Drainage Planning Conditions Supplementary Information

Subject: Land Off Elizabeth Street, Manchester

Ref: 080139

The Planning Permission Ref: 133125FO/2022
Variation Application number: 136813/JO/2023

PROPOSED DRAINAGE LAYOUT

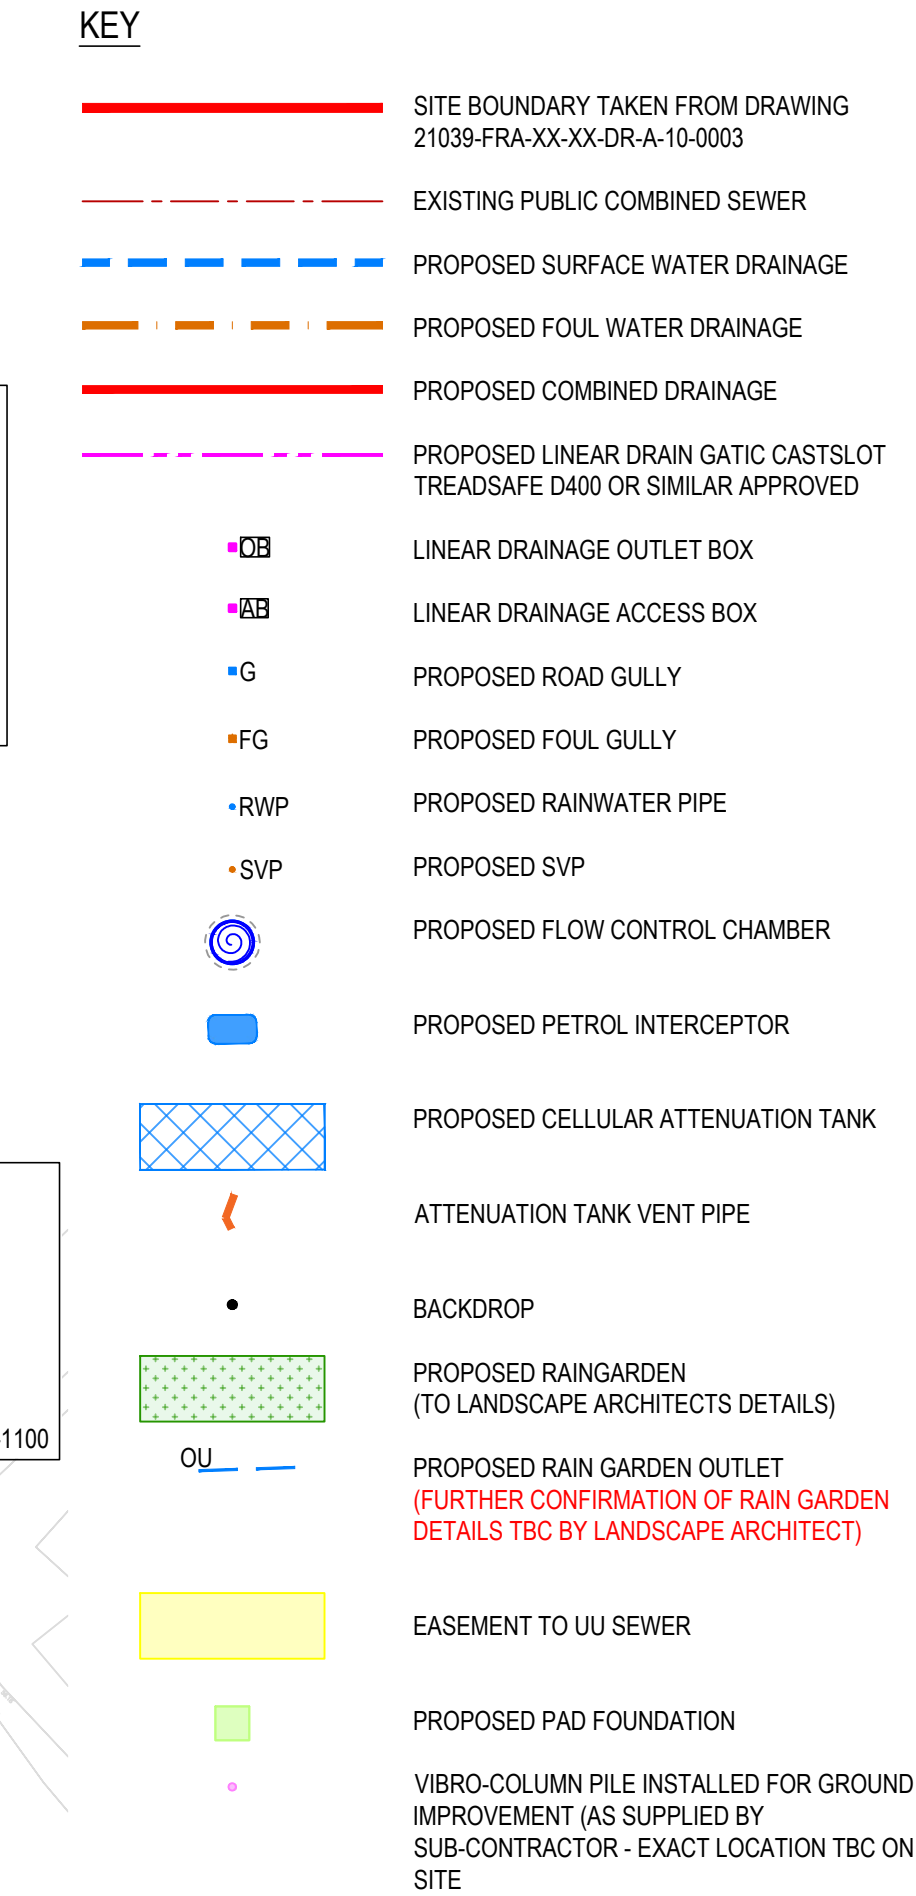
- Detailed drainage layout including labelled components, levels and connectivity; - **Cover levels and invert levels need to be accurately reflected within the Causeway modelling. Currently, there is a discrepancy between levels from drawing no. 080139 CUR XX XX D C 92500 P04 and modelling nodes. Route to outfall should also be clearly demonstrated within the drawing.**
The Causeway Flow Model has been updated to suit the current Drainage Layout. Please refer to Appendix A for:

- The proposed surface water sewer appears to clash with the existing foul public sewer, the developer will need to supply long-sections through the area in question for review.
Existing public sewer has been exposed at one location, upstream of the site crossing – grid reference E:384203, N: 400220.275. Drainage sections are provided in Appendix D.

- Drainage Layout
 - Manhole Schedule
 - Drainage Details Sheet 1
 - Drainage Details Sheet 2
 - Drainage Details Sheet 3Please refer to Appendix B FOR:
 - Causeway Flow Surface Water Calculations Without Surcharged Outfall

Orig Title: **TYPICAL DRAINAGE DETAILS SHEET 3**

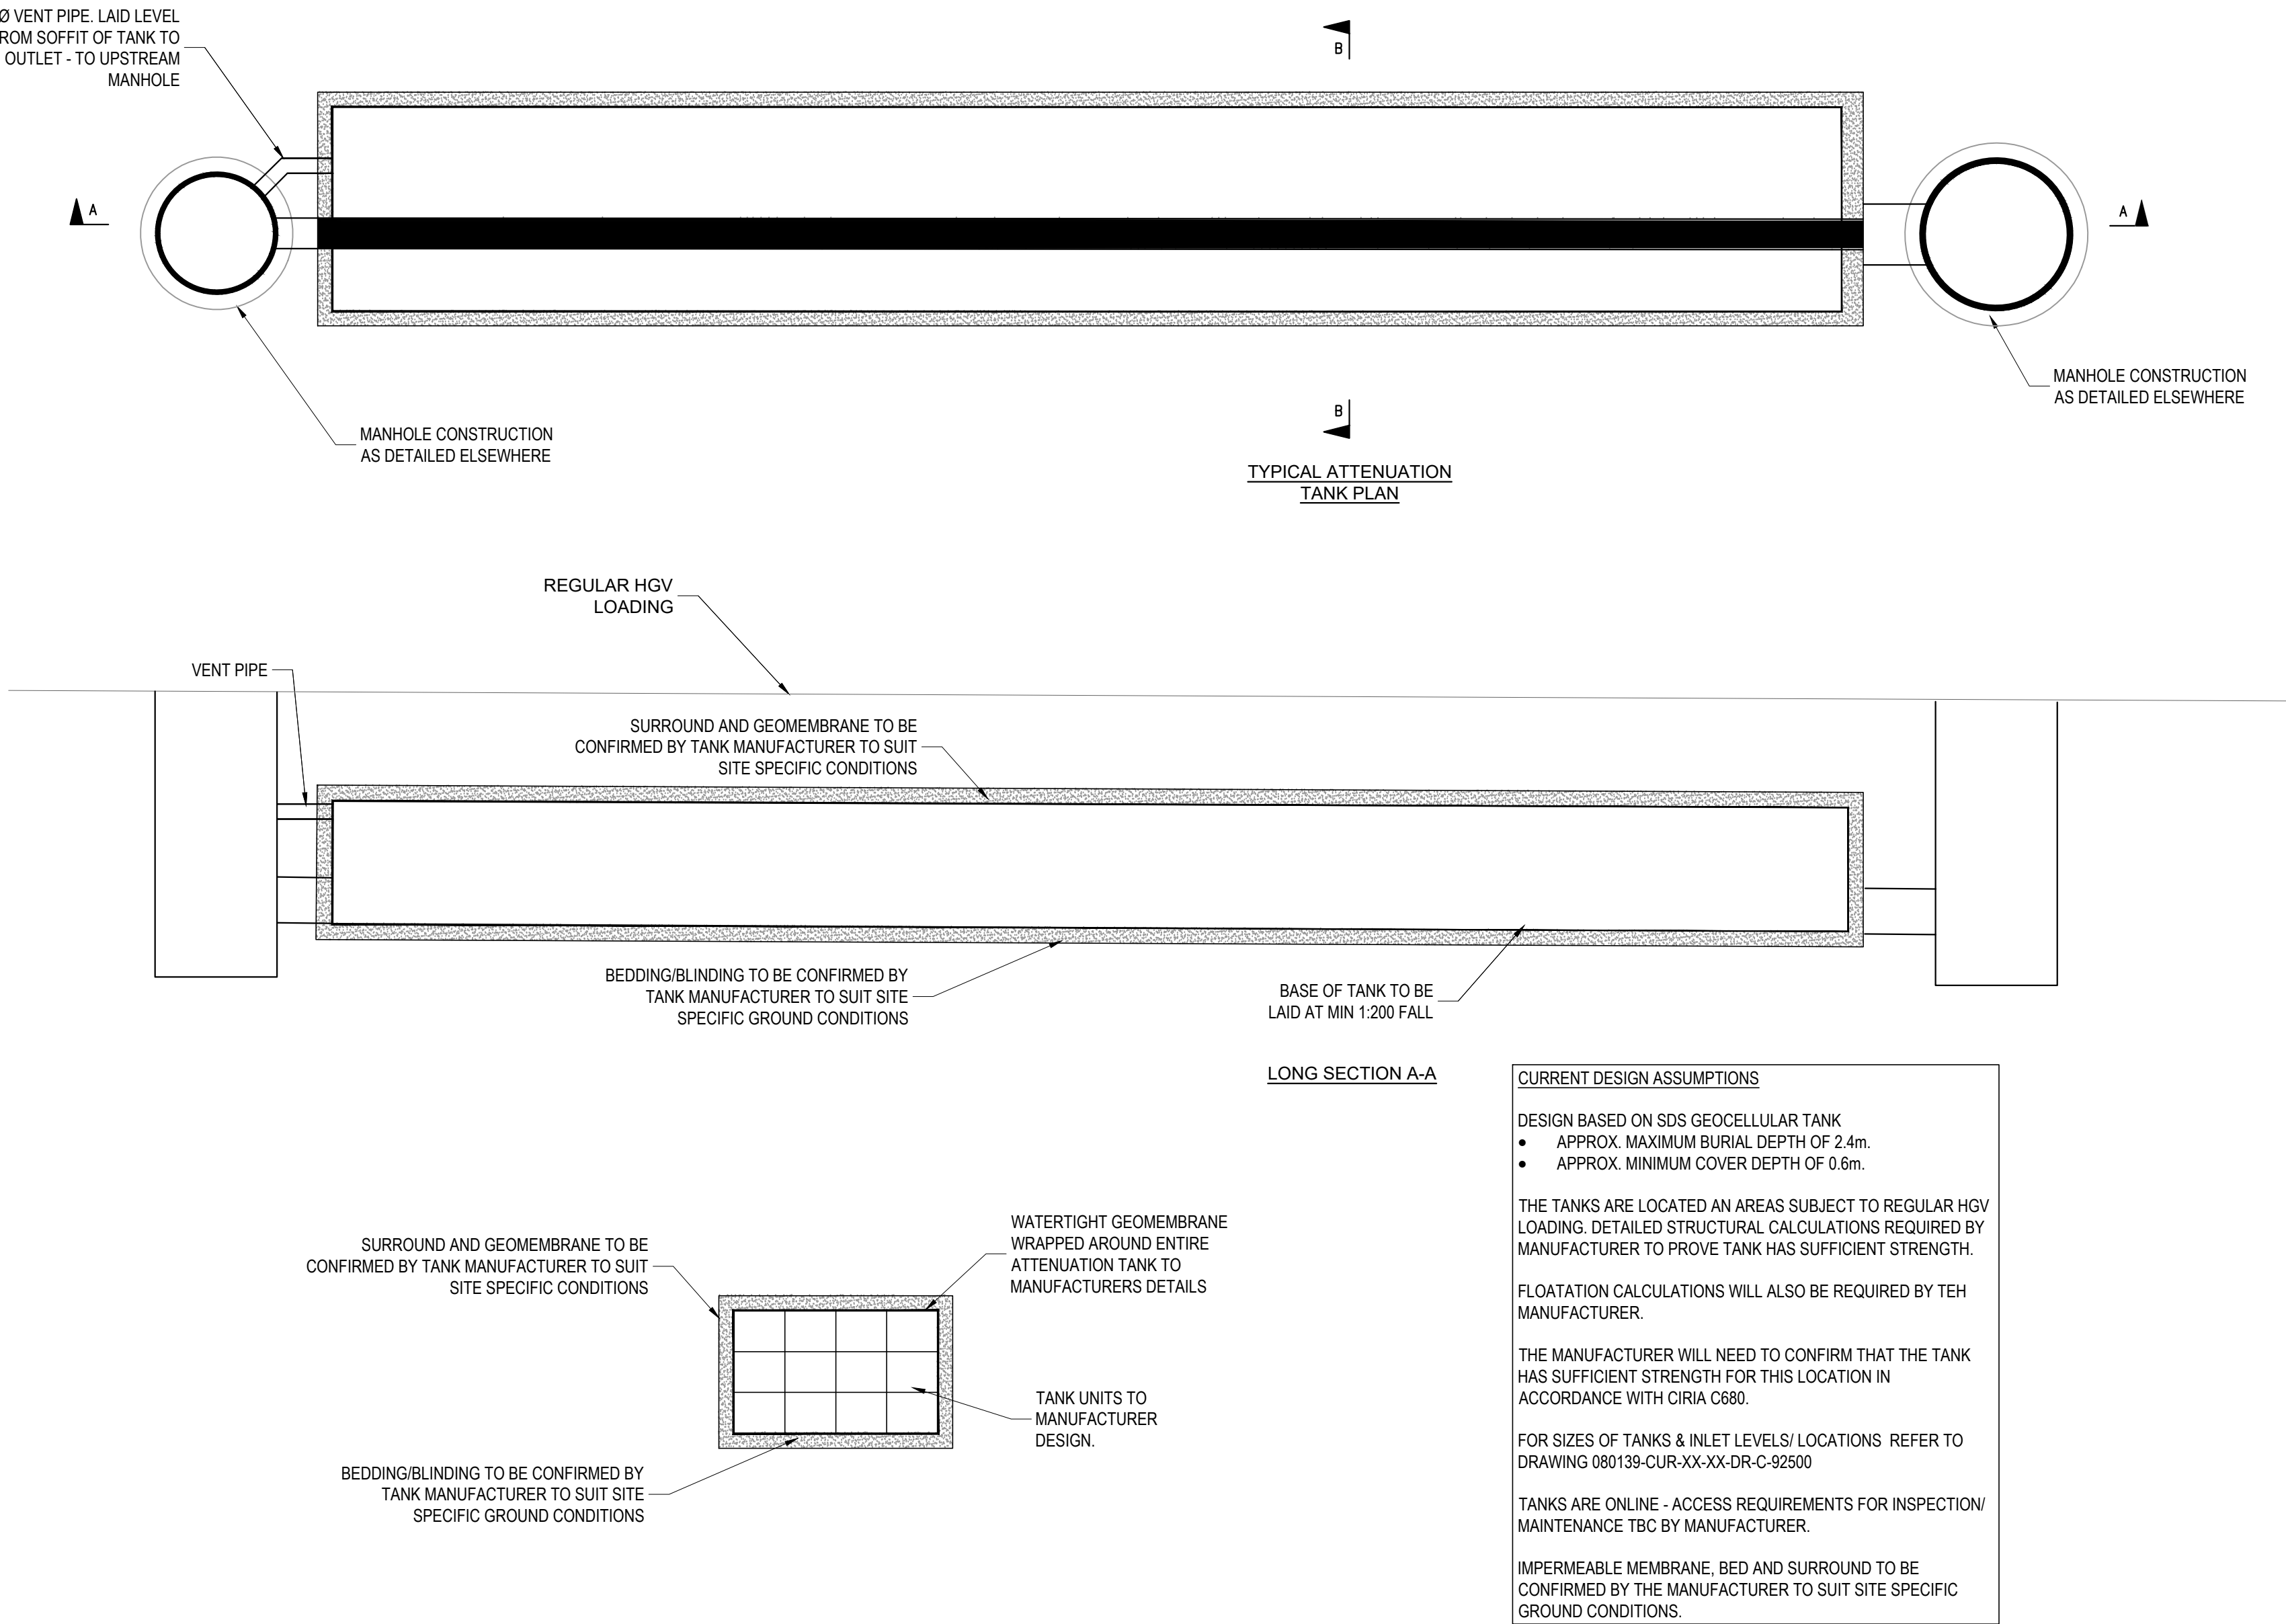
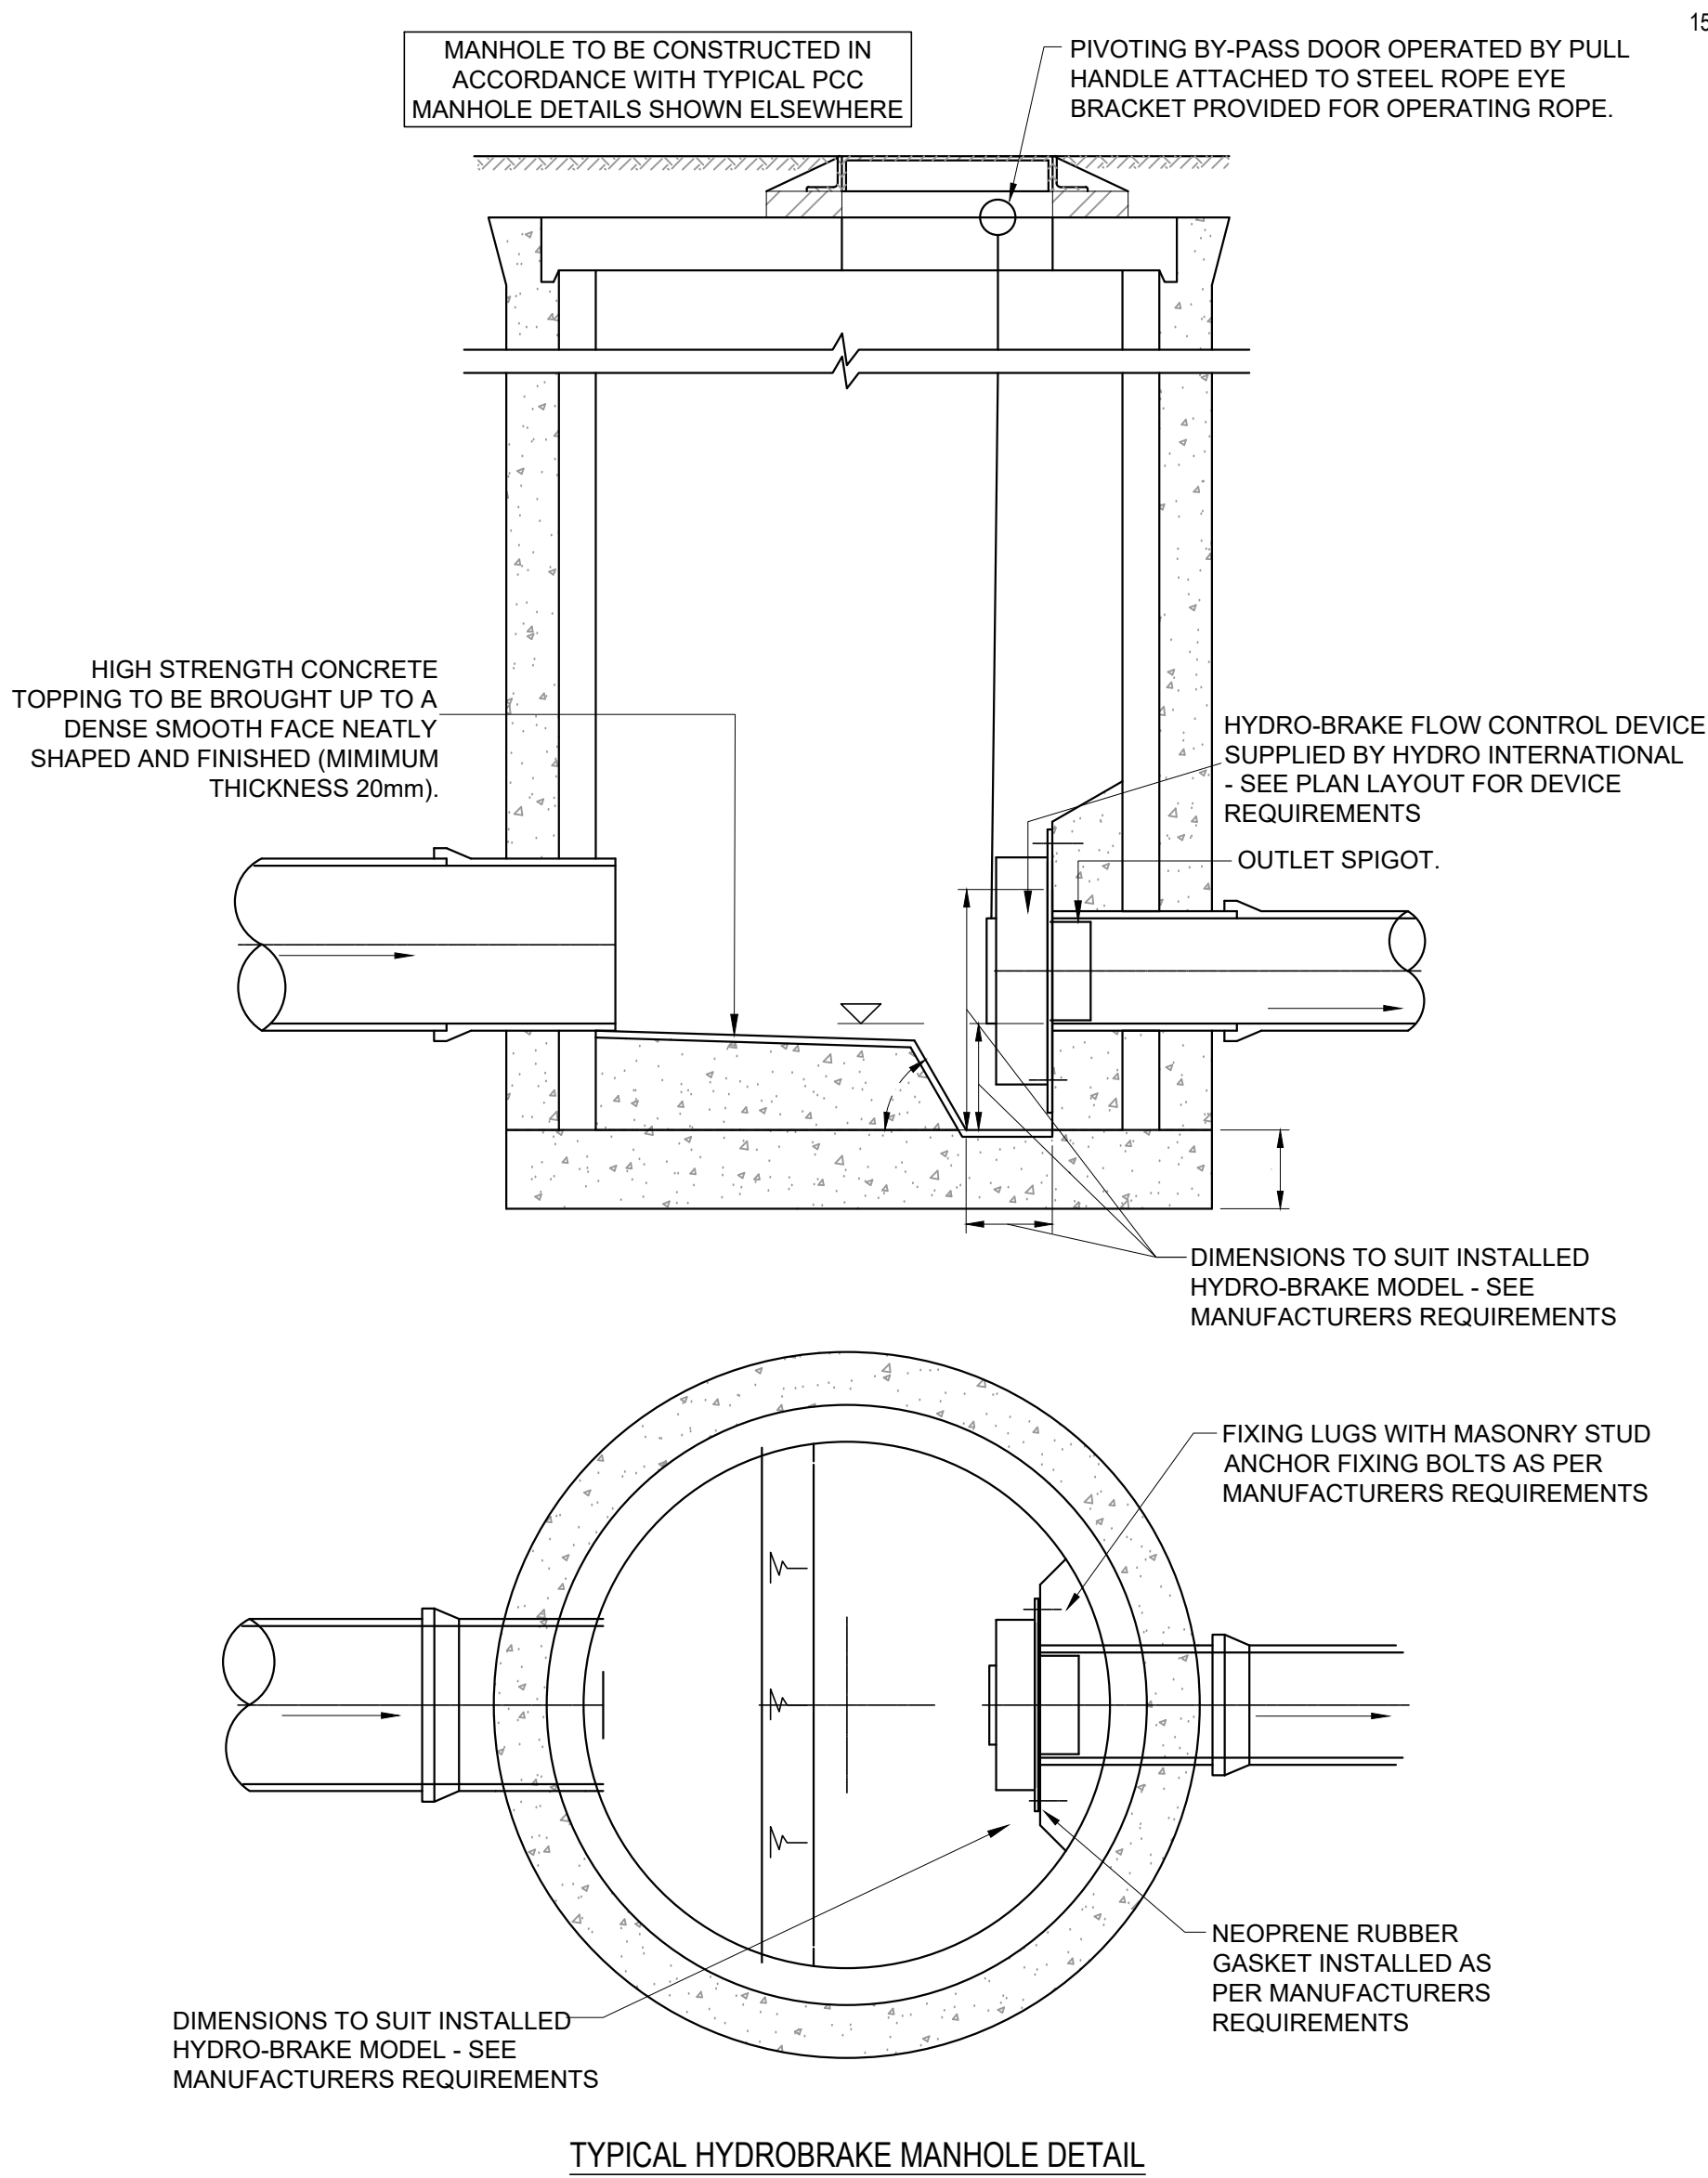
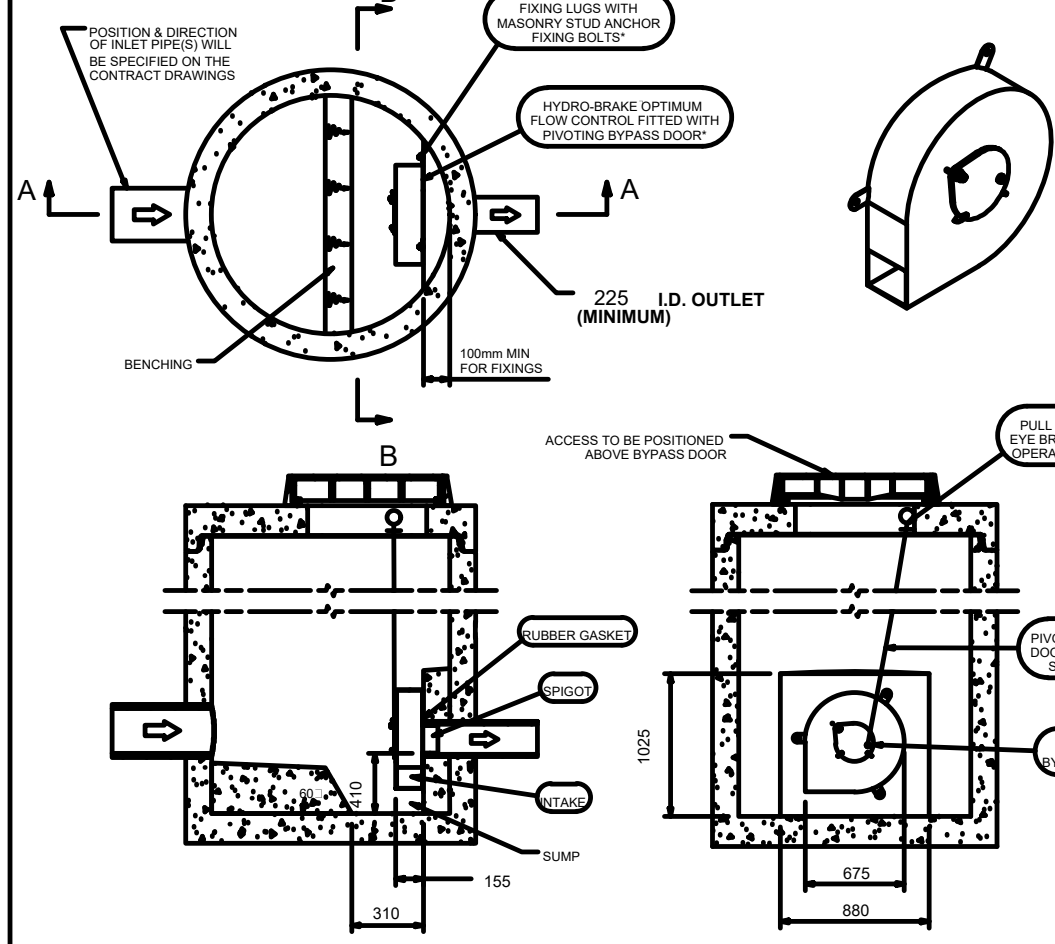
- Construction details of flow control and SuDS elements – Level of cover within the attenuation tank must be listed within the standard details; Typical drainage details sheet 3, 080139-CUR-XX-XX-DR-C-92522-P02. Details should be submitted for all SuDS components and reflect site specific details.

Attenuation Tank Sections have been updated, however they are generic as they refer to the manufacturer design. The contractor has proposed to use an SDS Geocellular tank and therefore SDS Details to be referred to.

Please refer to Appendix A for:
